**PCO #2 Water Line Work
required by the City of Savannah**

Service Center East
 OLD SAVANNAH AIRPORT TERMINAL

**RE: Gulfstream Service Center East
City Water Main Additional Services Request**

Change Order Request

C-004.1

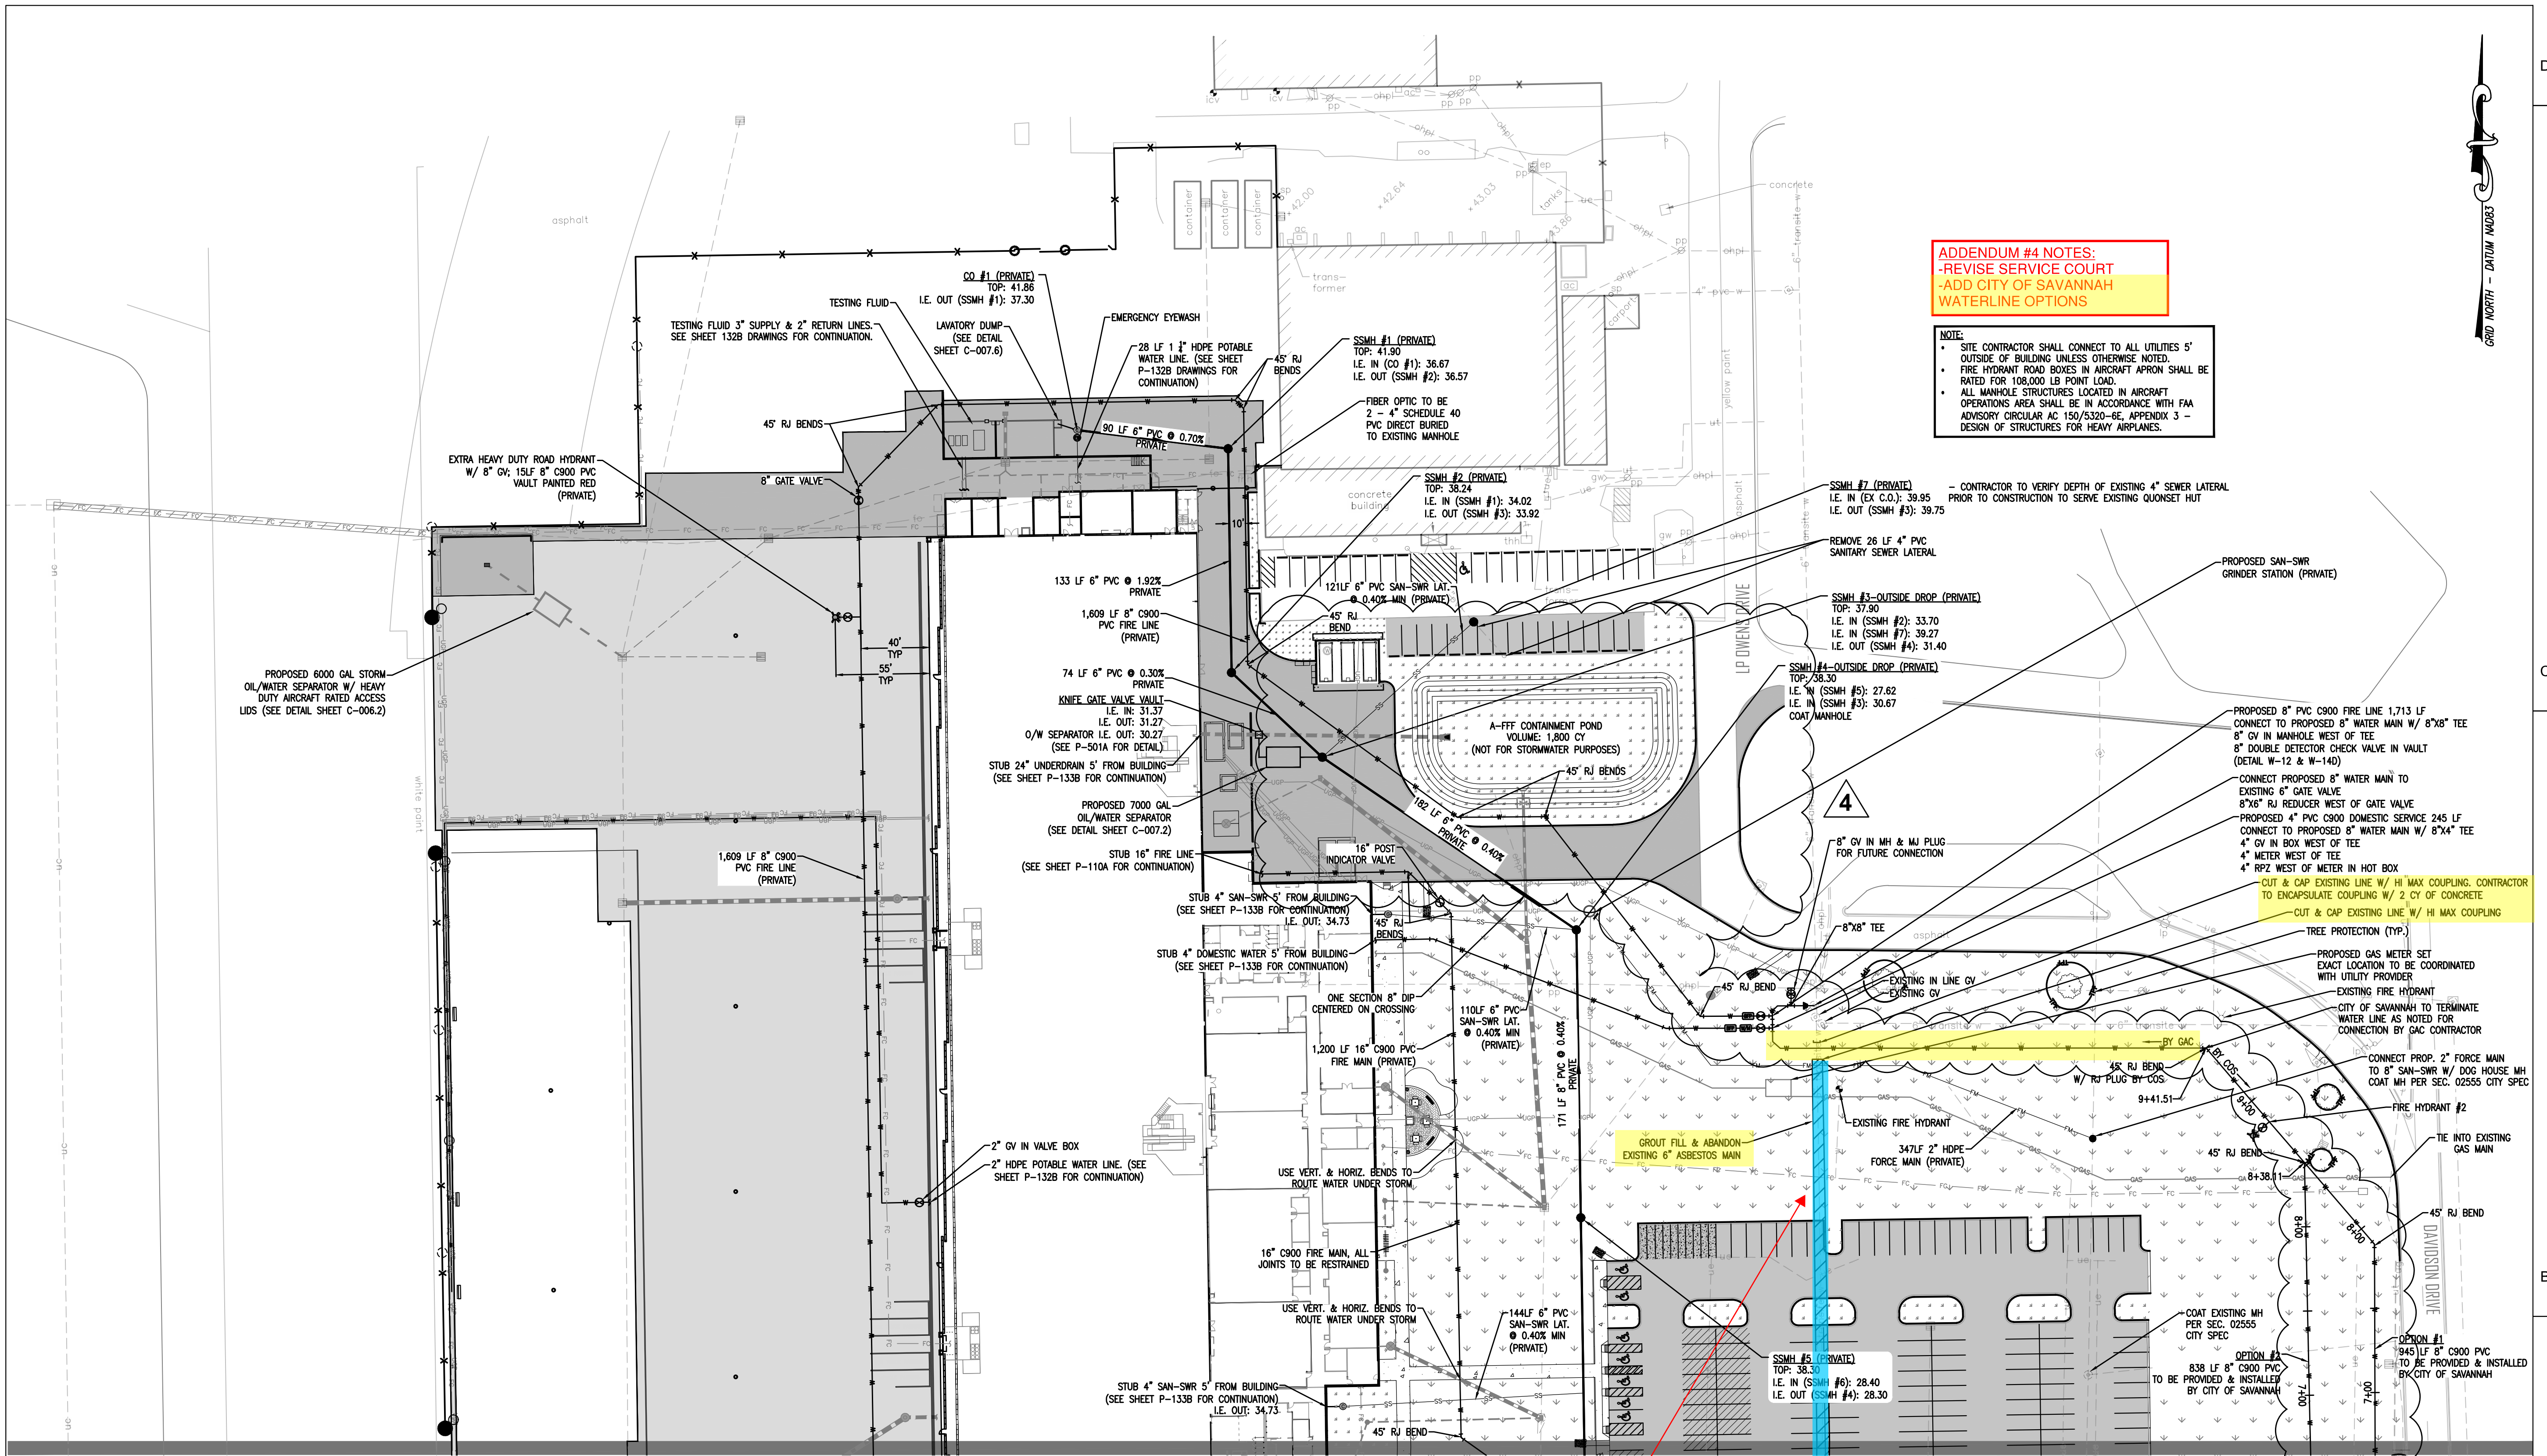
ADDENDUM #4 NOTES:
 -REVISE SERVICE COURT
 -ADD CITY OF SAVANNAH
 WATERLINE OPTIONS

Flowable fill Transit line (typical) continuation next sheet

C-004.2

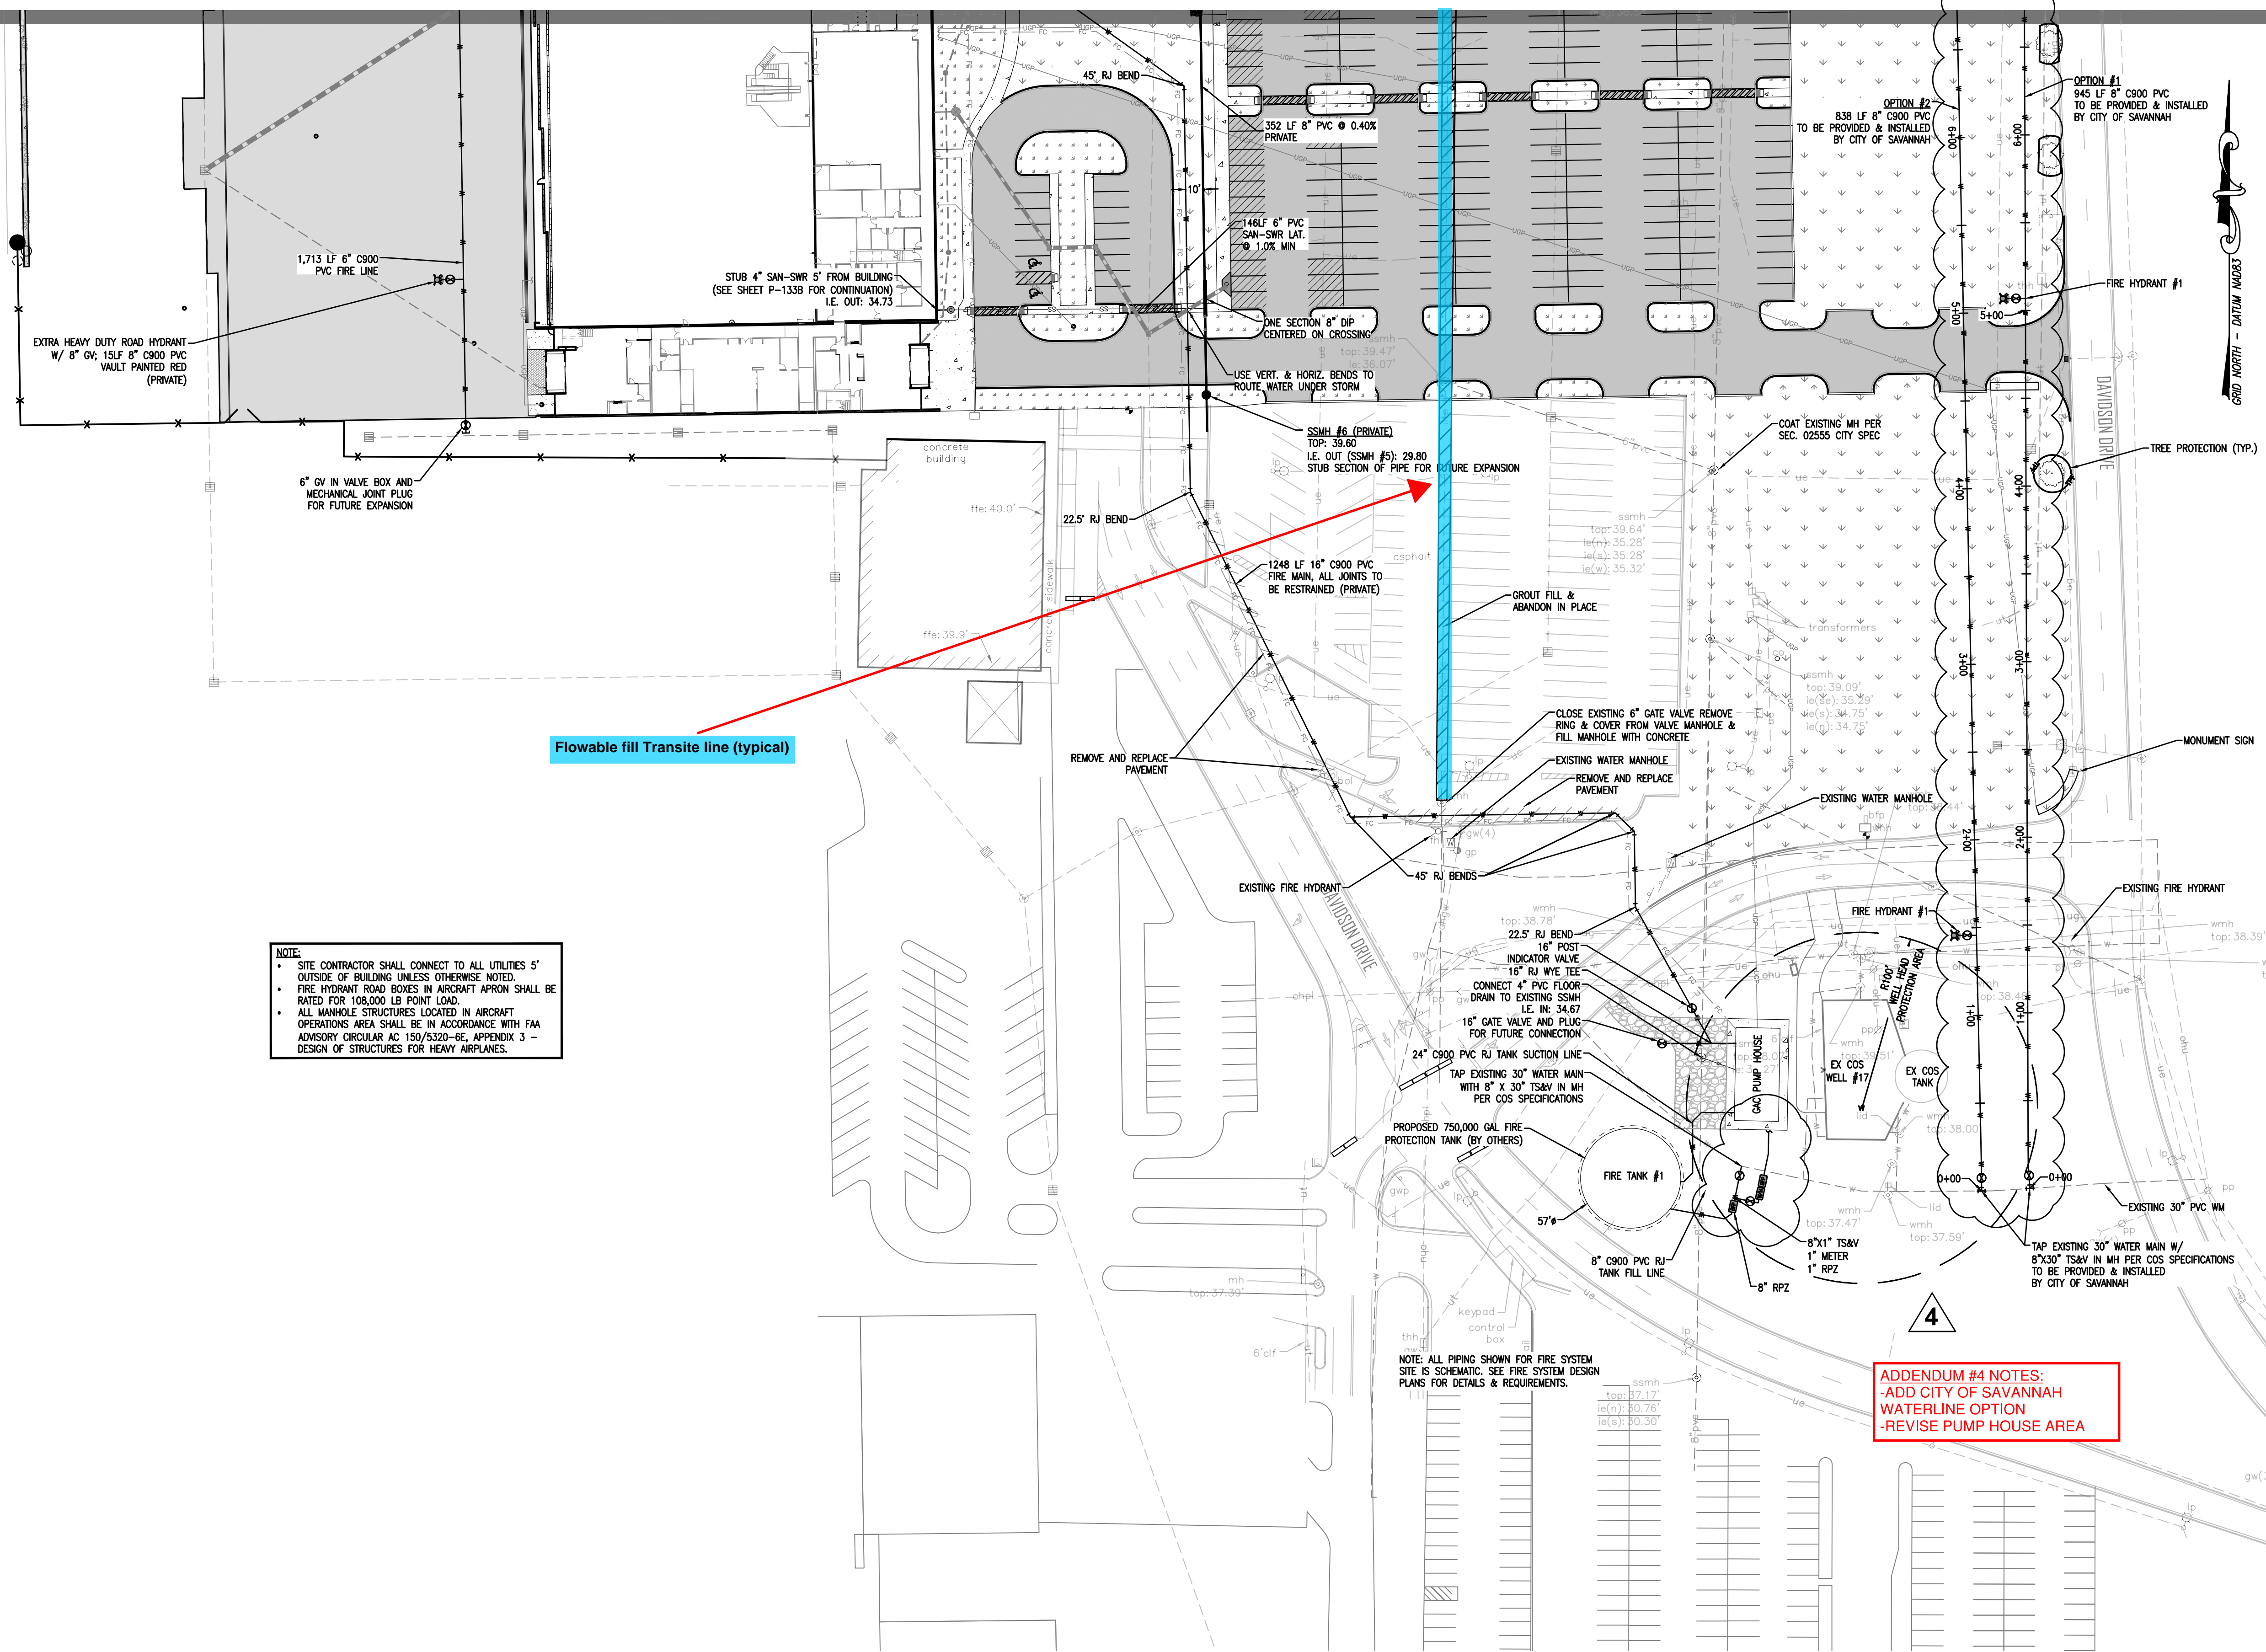
ADDENDUM #4 NOTES:
 -ADD CITY OF SAVANNAH WATERLINE OPTION
 -REVISE PUMP HOUSE AREA
